Subject: Interstate 4 from 1 Mile East of State Road 434 to Volusia County Line Value Engineering Study Recommendation Dispositions

FM: 242592-4

Interstate 4 from 1 Mile East of State Road 434 to Volusia County Line

Value Engineering Study **Draft** Report

RECOMMENDATION No. 21: Modify the 17-92 Alternative 1 to better accommodate traffic

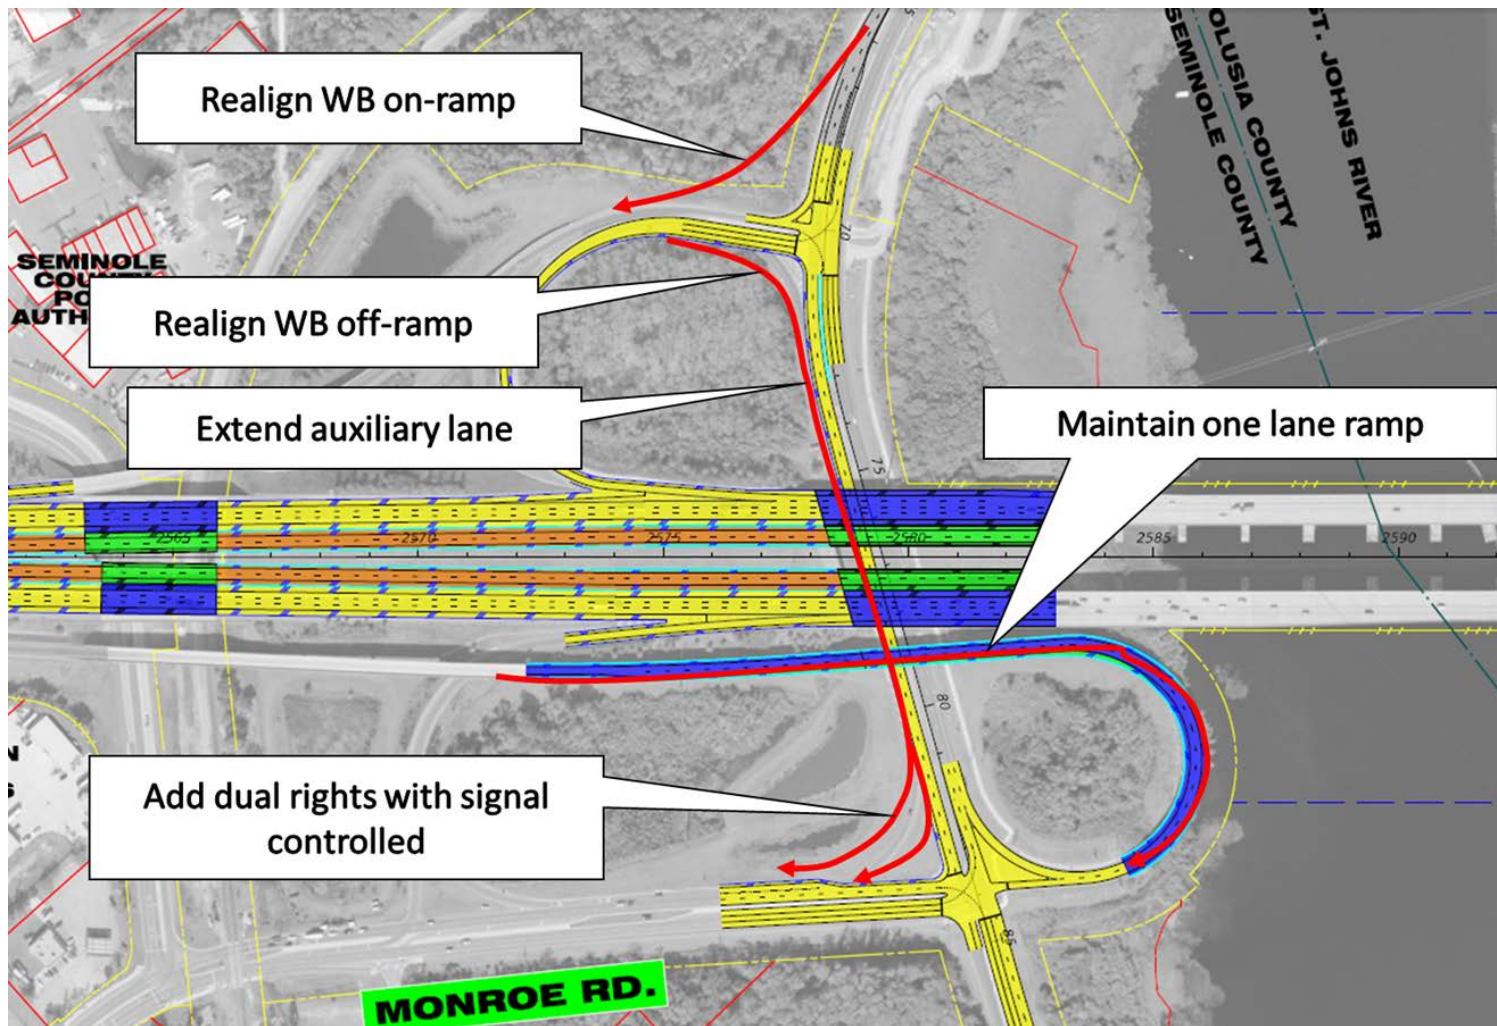
Recommendation 21: Modify the 17-92 Alternative 1 to better accommodate traffic by modifying Alt 1 to taper the US 17-92 SB to I-4 WB to eliminate the hard right and to add a third lane to Monroe Blvd and to add dual rights with stop control.

Accepted. The addition of the SB free flow ramp to WB I-4 provide some relief to SB 17/92, and the addition of the third lane and stop control at the intersection of Monroe Rd will add relief to motorist heading WB on 17/92 as head south on Monroe Rd to get to I-4 EB.

RECOMMENDATION No. 30: Modify the US 17/92 Alternative 5 interchange

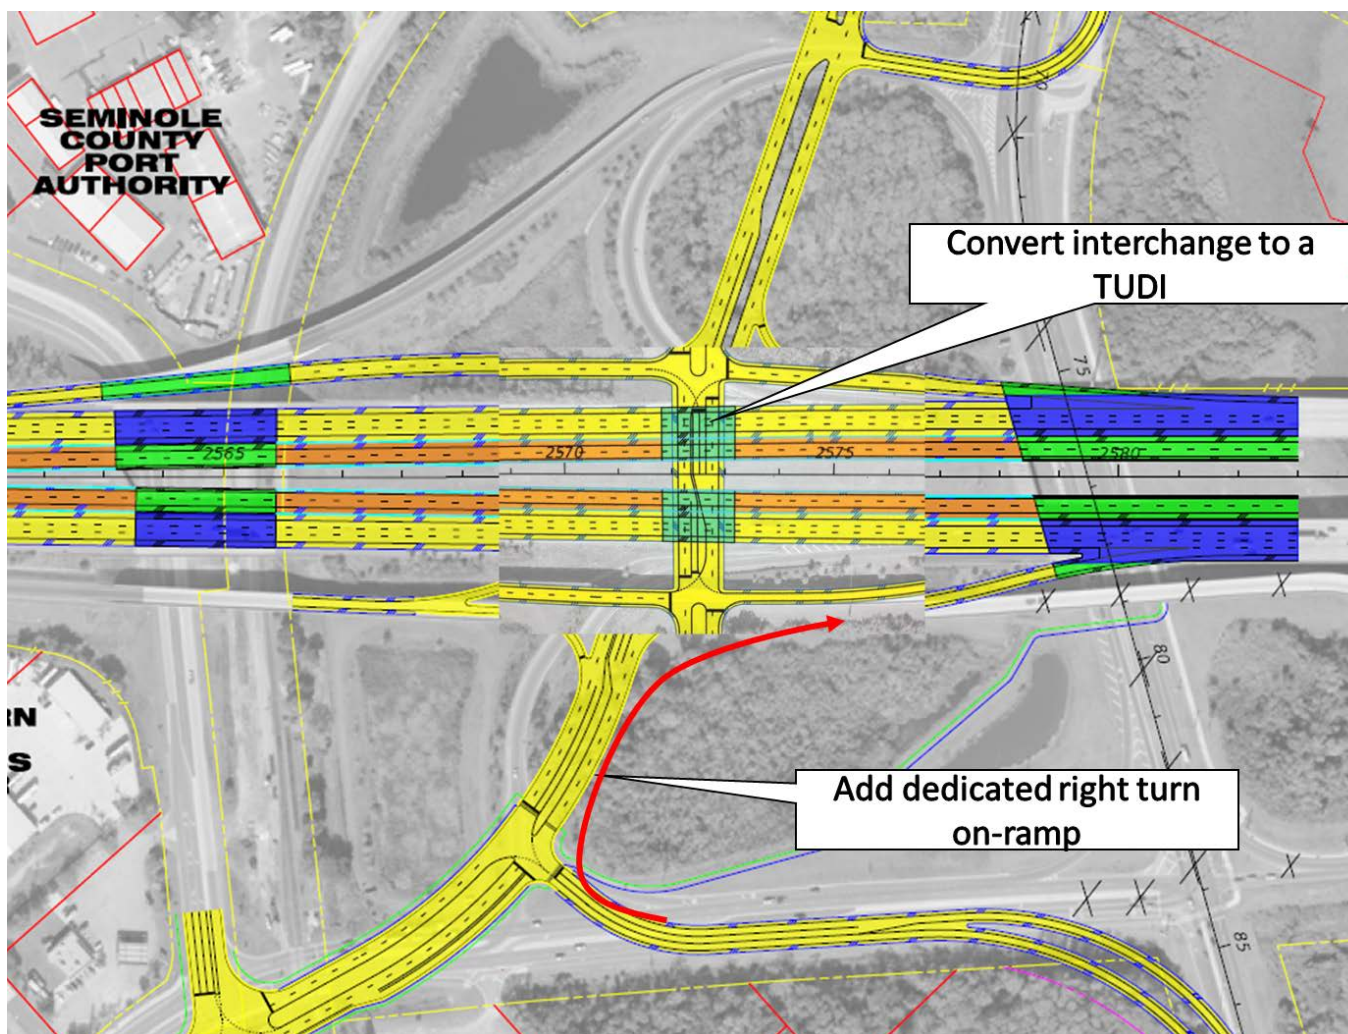
The PD&E Documents show the US 17/92 alignment shifting south then breaking just east of I-4 and tying into Monroe Rd. The other piece of US 17/92 is brought to the new alignment with a T-intersection. A single point urban interchange (SPUI) is provided for the US 17/92 & I-4 interchange.

Construct a tight urban diamond interchange at the US 17/92 & I-4 interchange. Additionally, provide a separate right turn for the eastern most alignment of US 17/92 to go to I-4 EB.

Accepted. The US 17-92 interchange will be modified to be a TUDI.
